# Exemption from Building Consent (exemption 2 only)

## APPLICATION FORM – BUILDING CONSENT EXEMPTION

Site leveling and construction of a new building next to the existing water reservoir using precast concrete panels.

**Gore Waste-Water Plant Peer Review**

STATUS <b>CONSTRUCTION</b>		
SCALE AT A1		
PROJECT NUMBER <b>20080</b>	DRAWING NUMBER <b>S01</b>	REV. <b>B</b>

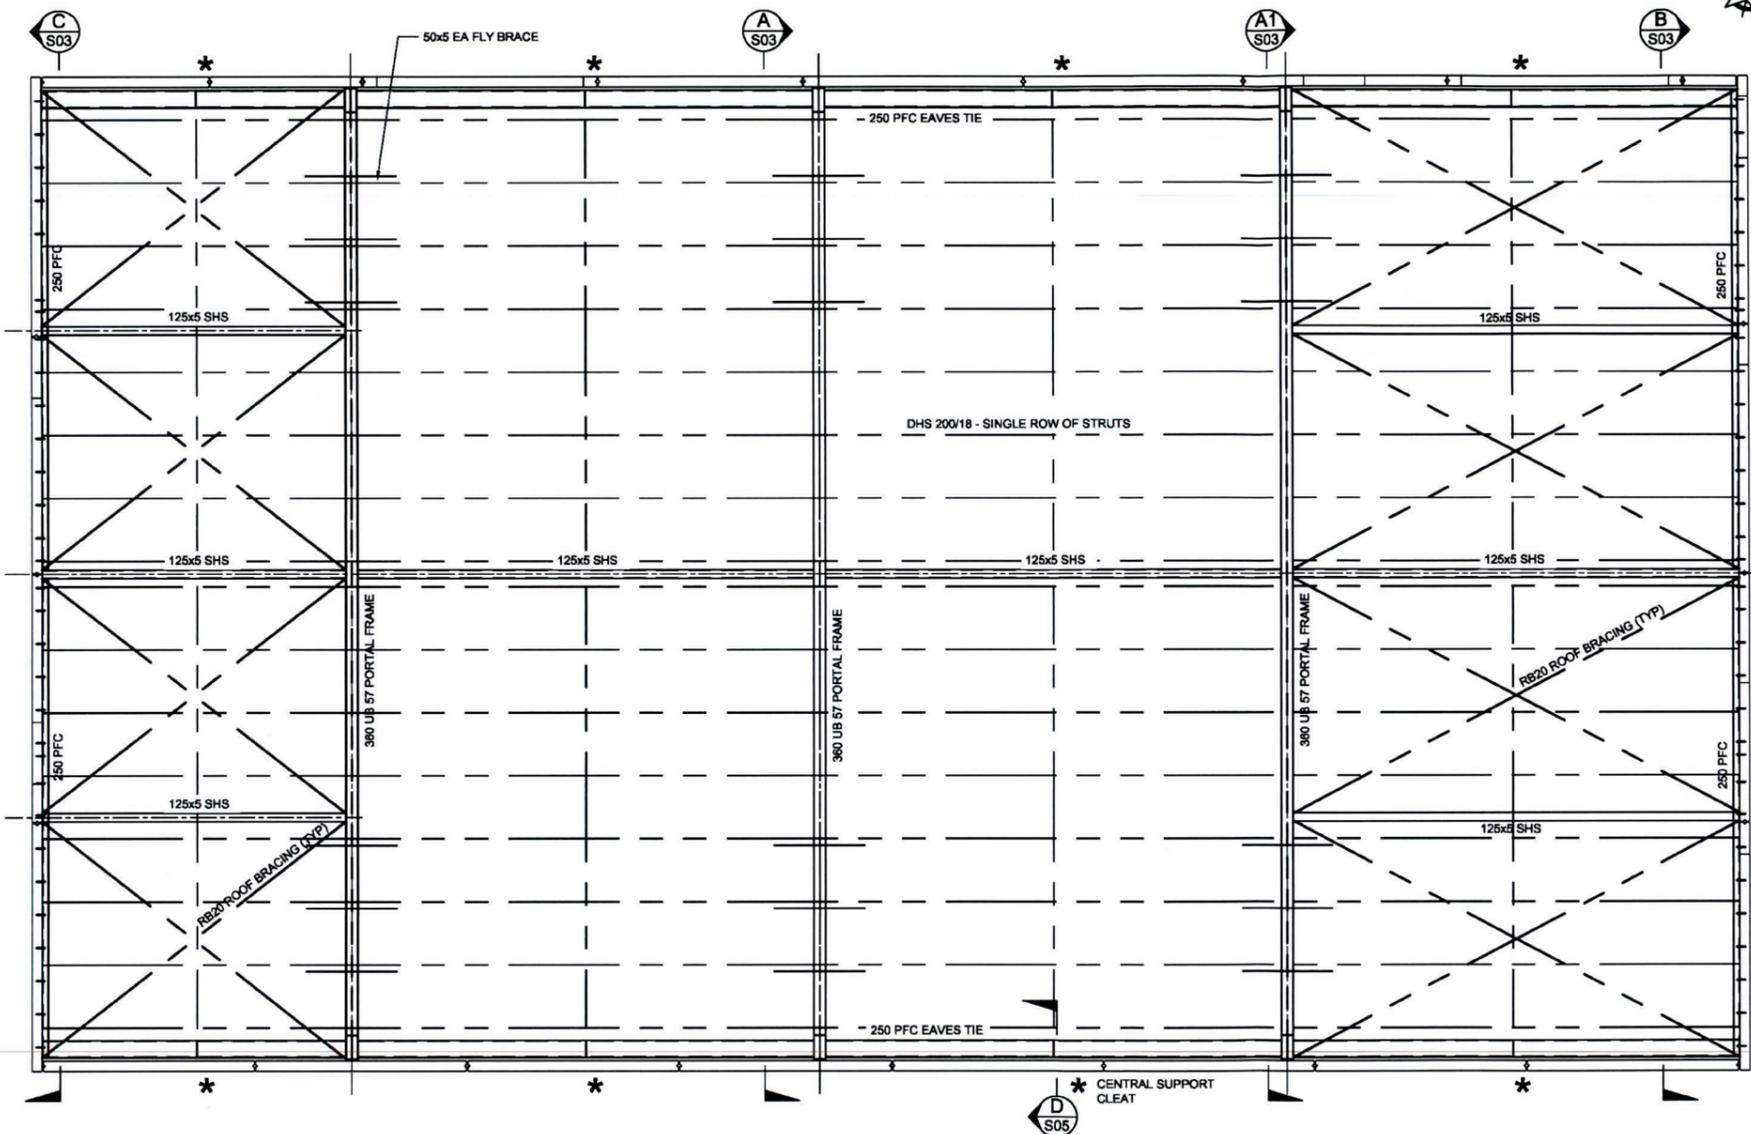
4	Drawing S01		25/01/21	Drainage outlets how are these detailed through the ground floor slab/beam? 23/4 - Detail updated, need to review		The drains have been regraded on revised drawings to enable the drains to exit out through base of the panel as detailed on sheet S04 section E1	28/05/21	P18 not updated with penetrations. Where does the chlorine room drain drain too? Are grates being provided over the strip drains.	15/06/21	The drain from the chlorine room exits via cored hole and pipe sleeve to external drainage sump beside the foundations. The external drainage works was not part of Kensington Consulting scope of work. Stainless steel grated drainage covers have been noted on the drawings as discussed with GDC. The drains exit out through base of the panel as detailed on drawing
5	Drawing S01		25/01/21	Is the dosage rate for the fibres, of 1 kg, for the whole floor slab or should this be a rate, ie xkg/m3? 23/4 - no update.		Yes confirming that the dosage rate is 1kg/ m3. Contractor is aware of this	28/05/21	Noted. We have not reviewed the dosage rate.

6	Drawing S01		25/01/21	The calls up for anchor studs as grade 8.8, should these be 4.6 for a bit more flexibility, although they have a lower capacity? 23/4 - no update.		This was originally a general note but is not really required now as all the various fixing requirements are specified where required. Drawing S01 Rev B revised to reflect this	28/05/21	Noted		
7	Drawing S01		25/01/21	Where studs are stainless steel, how is the bimetallic corrosion being dealt with? 23/4 - no update.		HDPE washers and epoxy paint coating. Revised section D / D1 sheet S04 Rev B	28/05/21	Noted		
8	Drawing S01		25/01/21	Are there any higher requirement of corrosion resistance to the steelwork in the chlorine dose room? 23/4 - No update.		This question was directed to our client who responded that no additional coating requirement was required. Copy of email response attached refer query 8 document	28/05/21	We would recommend that this is reviewed by a corrosion specialist.	15/03/21	Coating spec changed in steel spec however contractor has offered an PURB compliant alternative which is acceptable and we will accept

STATUS <b>CONSTRUCTION</b>		
SCALE AT A1		
PROJECT NUMBER <b>20080</b>	DRAWING NUMBER <b>S02</b>	REV. <b>B</b>

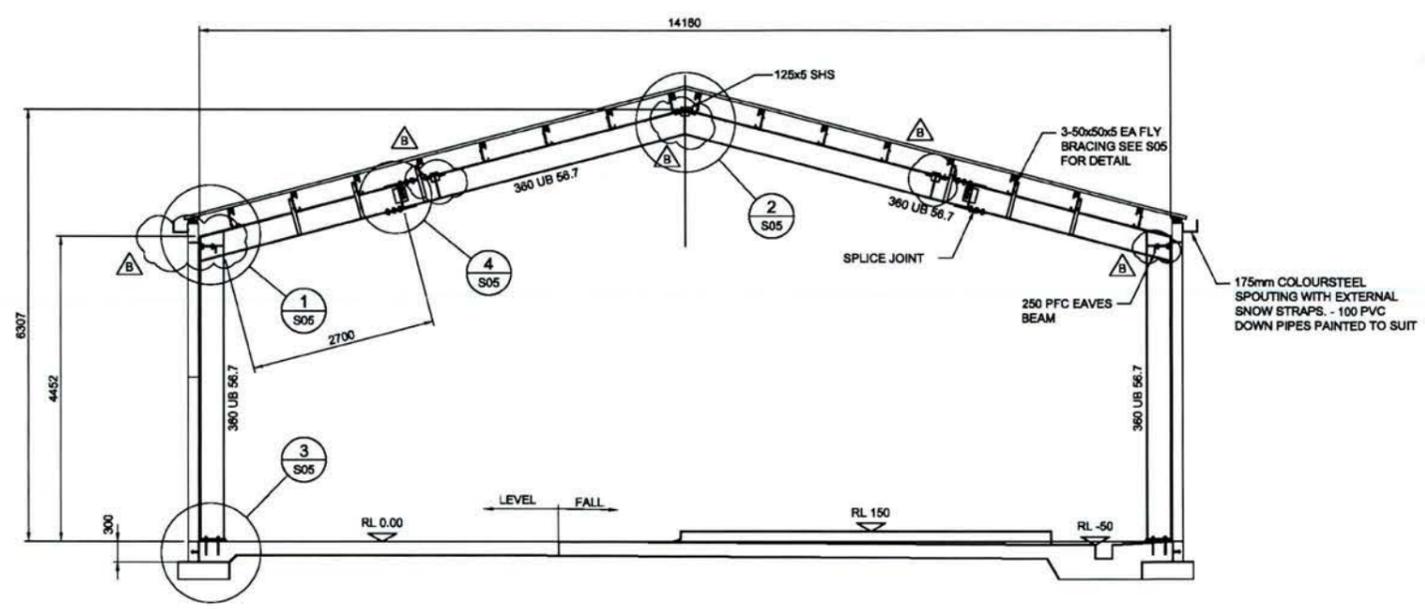
11	Drawing S02		25/01/21	Has the eastern wall been designed to take approximately 10m trib of seismic load for the building? 23/4 - calcs to be reviewed.		Current detail of the pillar is fine. Just drawings to be updated. Trimming bars are added. See page RFI-2. Revised details for P22 drawing S08 Rev B	28/05/21	Noted	15/06/21	Refer to revised calculations and panel drawings
12	Drawing S03		25/01/21	Section C needs updating to show the pillar in panel P22. 23/4 - drawings still inconsistent. Strip of panel adjacent to penetration needs to be detailed appropriately		See page RFI-3	28/05/21	Use of Mu = 1.25 and sp =0.7, is not ok for this connection. Further not considered the combined tensions and shear load. Tension and eccentricity not accounted for together.	15/06/21	Refer to additional calculations
13	Drawings S04 and all Precast wall elevations		25/01/21	Are the HD12-300 shear bars at the base of the precast walls enough for vertical and horizontal loads? How is the eccentricity resolved?		The uplift is not too high due to self weight of the walls and light roof. The anchorage capacity of base is checked see RFI-3	28/05/21	300 kN/m of uplift is high. There is not enough self weight for this.	15/06/21	Refer to additional calculations

STATUS <b>CONSTRUCTION</b>		
SCALE AT A1	DRAWING NUMBER	REV.
PROJECT NUMBER <b>20080</b>	<b>S06</b>	<b>A</b>

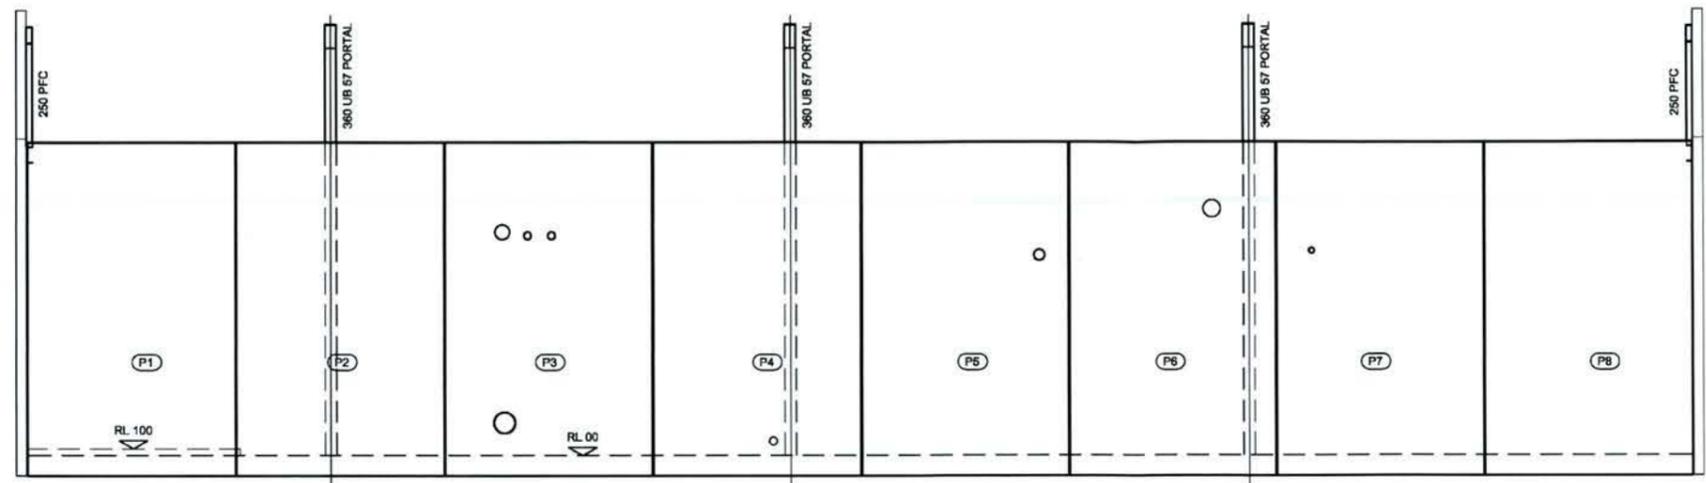
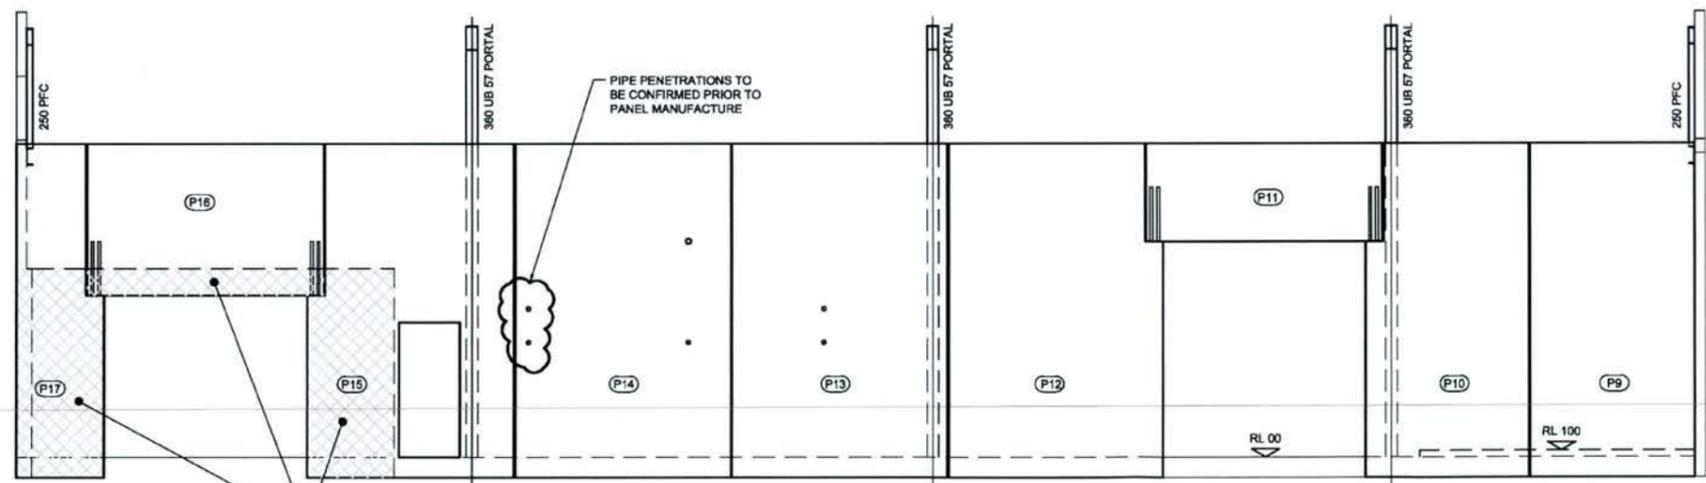
14	Drawings S04 and all Precast wall elevations		25/01/21	Under seismic actions how is the panel held down. The uplift seems very high. 23/4 - calcs to be reviewed.		Attached marked up plan which has incorporated the contractors construction joints	28/05/21	Noted		
15	Drawing S04		25/01/21	Saw cuts in the slab, detail is shown but plans do not show layout and location, how does these interact with the plinths? 23/4 - no update.		They can be resisted by the sections capacity See page RFI-5	28/05/2021 09/07/2021	Weak axis being of rafter not checked with major axis bending. Unclear as to how SHS has been checked. Brace connection capacity insufficient (S05, section B and plan). Recommend centrelines of SHS strut, UB portal and Reid braces align, with bolt sizes increased to M20's (same as RB20 pins) and in line with RB centrelines to take force without any eccentricity. Connection has not been reviewed for eccentricity.	15/06/21	refer additional calculations

STATUS	CONSTRUCTION	
SCALE AT A1	PROJECT NUMBER	DRAWING NUMBER
	20080	S13
		REV. C

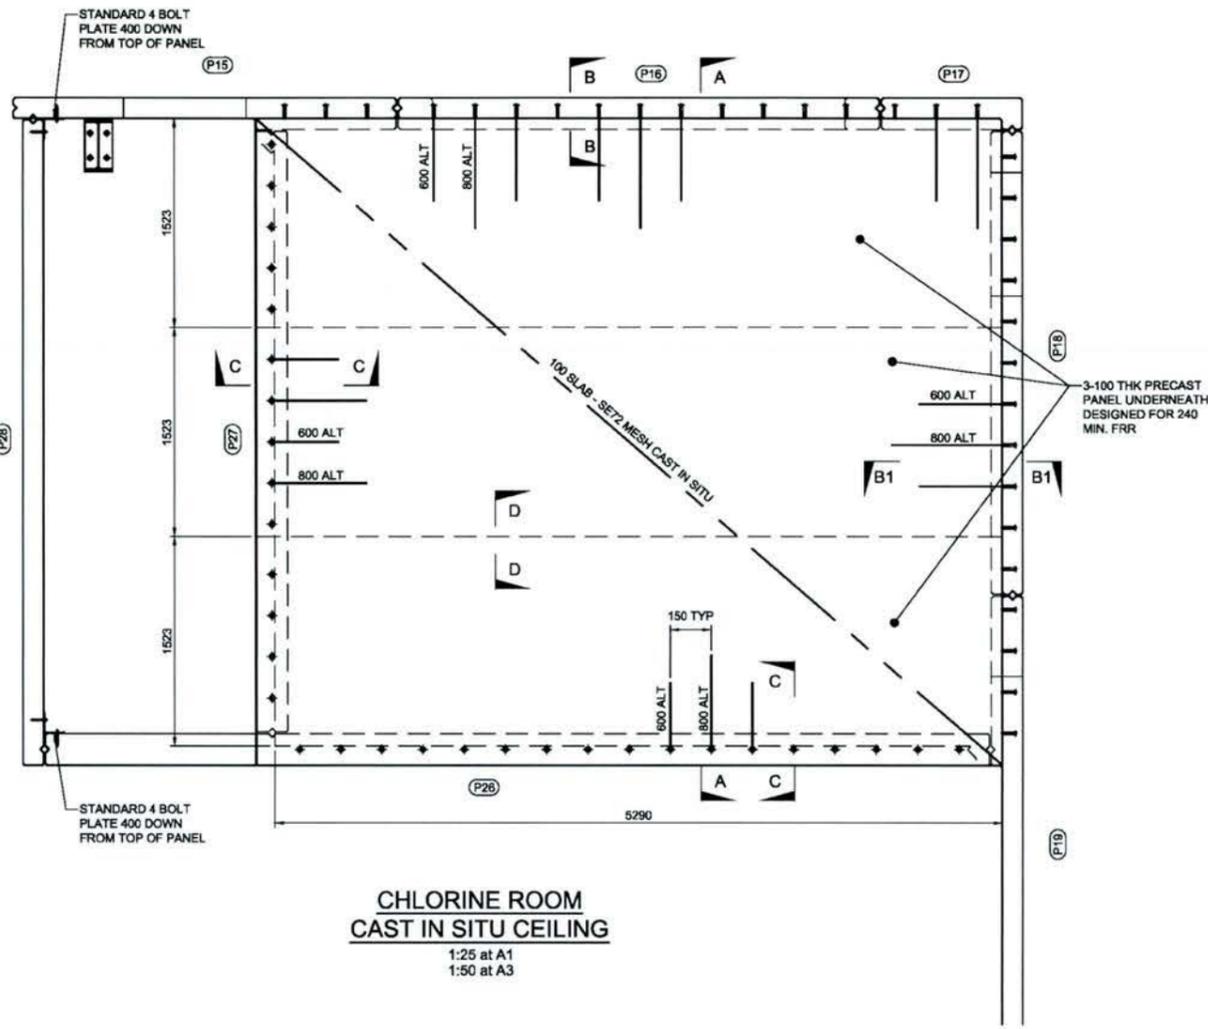
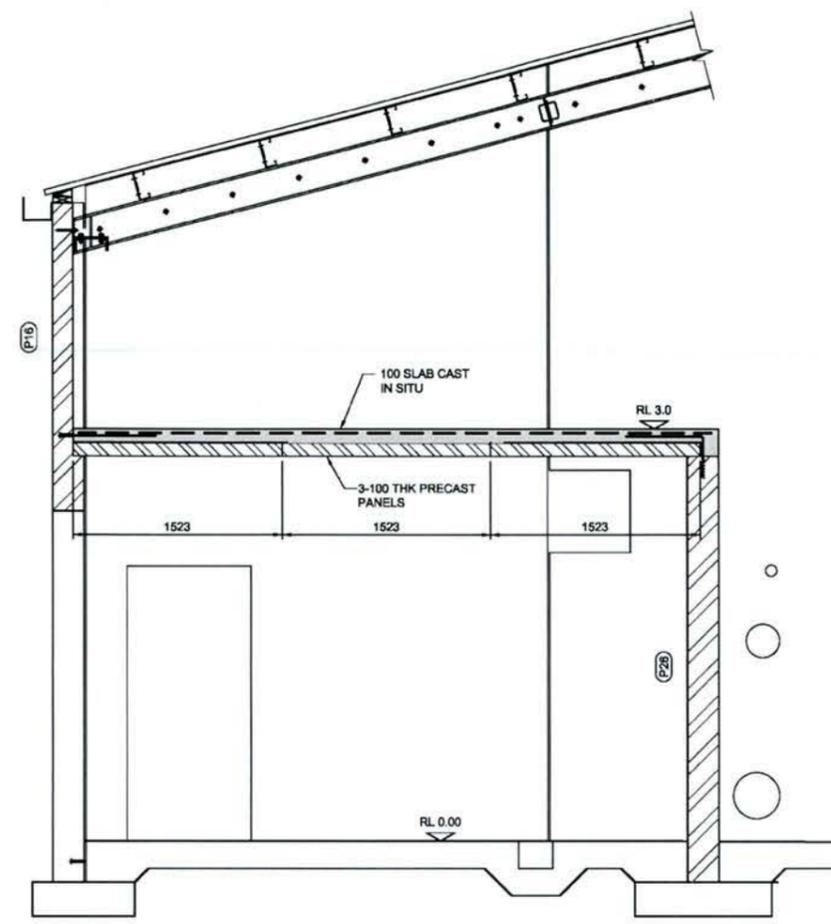
9	Drawing S13		25/01/21	Loads for the design of the precast floor units that form the roof to the chlorine room have not been provided. Please provide.		This was intended as a ceiling only but have allowed for a nominal 3Kpa UDL in case of some minor storage as access is very restricted but have allowed for a point load of 1kN for a There is a 100mm step in the slab at the offices end of the building and sheets S 01 and S04B. Indicate these details	23/04/2021 28/05/2021	Drawings updated for live load. Point load not specified. Need to specify point load to NZS 1170.	15/06/21	The as agreed 3.5KN point load in addition to the 3KPa UDL has been added to the drawing S13 and the precast spec updated.
10	Drawing S01		25/01/21	Is there a fold in the ground floor slab, we believe there should be, if so what is the detail. 23/4 - no update.		Yes, See page RFI-1	28/05/21	Unclear if panel are tied together and detailed as such.

**ROOF SLAB DESIGN LOADS**  
 100 THK PRECAST PANEL DESIGNED FOR 240 MIN. FRR SELF WEIGHT INCLUDING TOPPING.  
 SUPERIMPOSED LIVE LOAD - 3KPA UDL AND 3.5KN POINT LOAD. APPROPRIATE DESIGN FACTORS AND COMBINATION OF LOADING SHALL BE APPLIED TO THESE LOADS. DESIGNER TO PROVIDE PS1.
